Addendum to the

Apple II Reference Manual

APPLE Part #Ø31-ØØØ4-A

Replaces Figure 22-1. Schematic Diagram of the Apple II

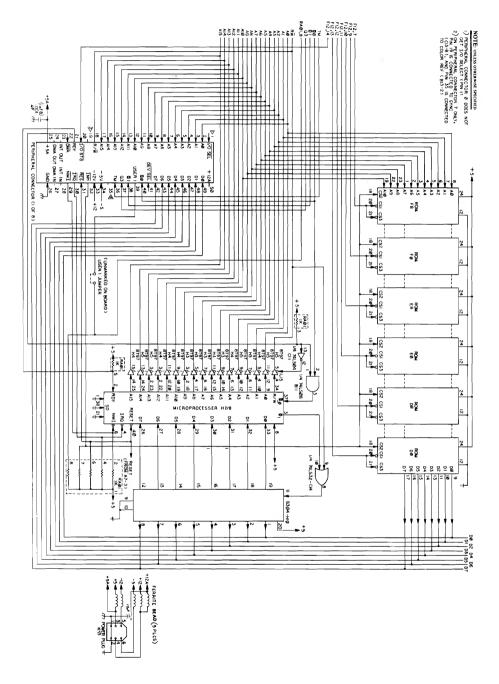
The major differences in the new main board are described below. Also, the attached schematics show the areas in which this board is different from earlier boards. You may wish to note these differences in your Apple II Reference manual, on the pages which correspond to the schematics here.

- * The new board does not have RAM configuration blocks. This means the RAM Integrated Circuits (ICs) which give your Apple its memory MUST be 16K bit ICs. All of the RAM ICs in your Apple are within the white-outlined box on the board. If you add memory to your Apple, make sure all the ICs you add in this box are 16K RAM.

- * The IC which controlled the configuration blocks in the older versions of the Apple II board is no longer there. It was formerly in the E2 position on the Apple board (in the row labeled E, the second IC from the left of the board) and was marked 74LS139.

Replaces Figure 22-2. Schematic Diagram of the Apple II

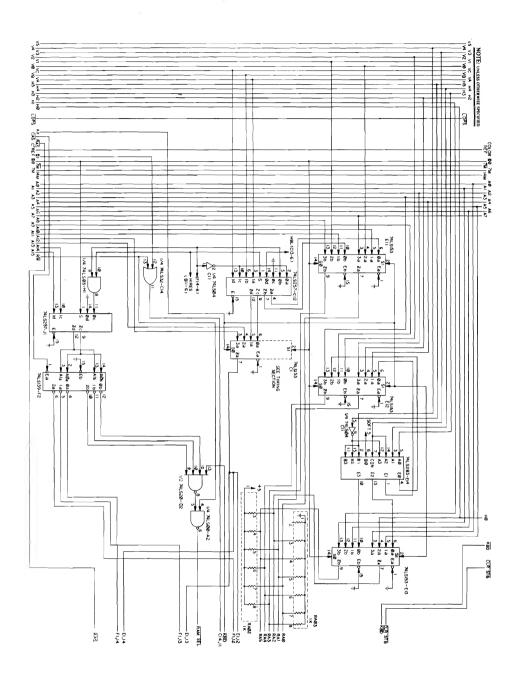
- * This new board has a different character generator ROM IC. The character generator ROM IC determines what style of lettering, or character set, you'll see on your monitor or terminal screen. The new character generator ROM is found next to the Keyboard socket on the main board. This 2316B ROM has much more ROM (Read Only Memory) space than the former 2513 character generator ROM, so that it's possible to have more than one character set available. The 2316B ROM can also be replaced with a 2716 EPROM, which allows you to program and change your character sets.

Replaces Figure 22-3. Schematic Diagram of the Apple II

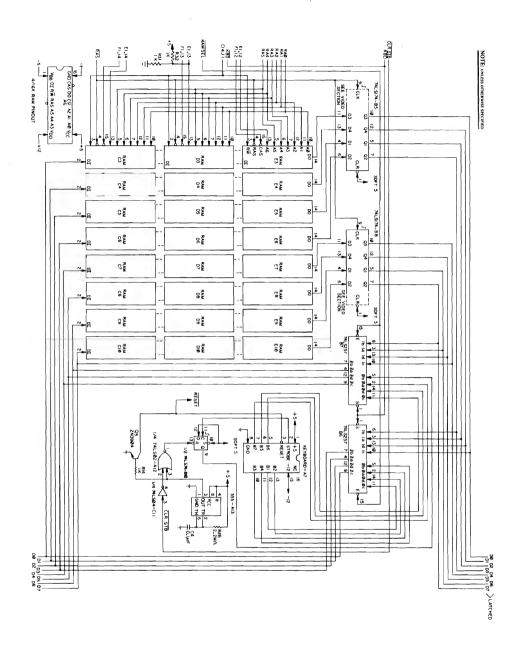
- * An inverter circuit has been added in the H2 line, which is a video synchronization signal. This alters the video synchronization pulse rate of the Apple so that is more compatible with video monitors that have digital synchronization circuitry.

Replaces Figure 22-4. Schematic Diagram of the Apple II

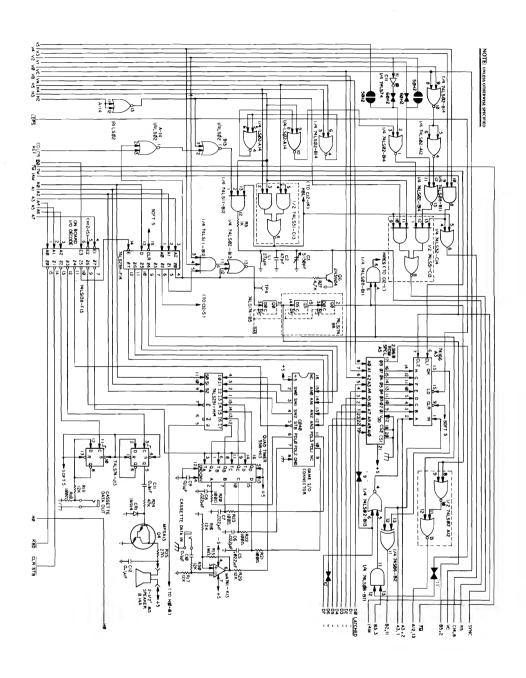
- * The power and ground system has been redesigned. The +5V and ground bus on the rear of the board have been interchanged so that the +5V bus is on the top of the board and the ground is on the bottom. A grounding bar has been added under the board to ensure electrical contact between the board and the metal baseplate.
